Docket Item # 12
BAR CASE # 2009-0151

BAR Meeting
July 29, 2009

ISSUE: Alterations
APPLICANT: James McNeil
LOCATION: 1 Wharf Street
ZONE: W-1/Residential

Figure 1: Plat showing HVAC condensers and landscape screening.

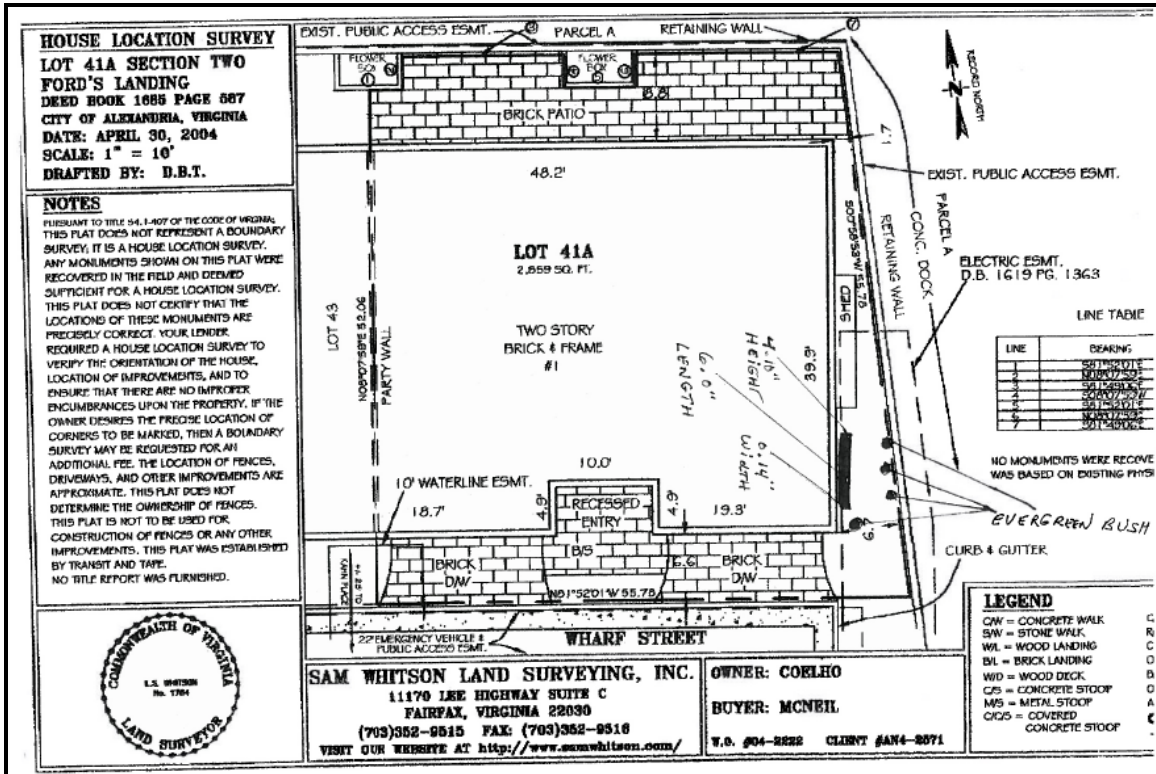
The four new ground mounted units (stacked two high) sit on a concrete slab measuring approximately 14 inches wide by 6 feet long in the same general location as the wall mounted units. Each Carrier Performance Series horizontal condenser measures 1 foot 11 inches by 3 feet 6 inches. The resulting void where the through-the-wall units were located was infilled with a matching brick. Evergreen shrubs have been installed to screen the condensers.

mounted HVAC units. In Staff's opinion, the new HVAC condensers are located in an ideal location and will be minimally visible from the public right-of-way. While Staff would have preferred that the applicant wait until the BAR approved the project, the end result is acceptable.

F-1 The subject property is located in the 100-year floodplain. The floodplain ordinance requires that all mechanical and electrical equipment be elevated above the Base Flood Elevation (BFE). As-built drawings of Ford's Landing indicate that the lowest floor of the subject property is elevated above the BFE. Therefore, installation of replacement compressor units at an elevation at or above the lowest floor (garage floor) would be in compliance with the floodplain ordinance.
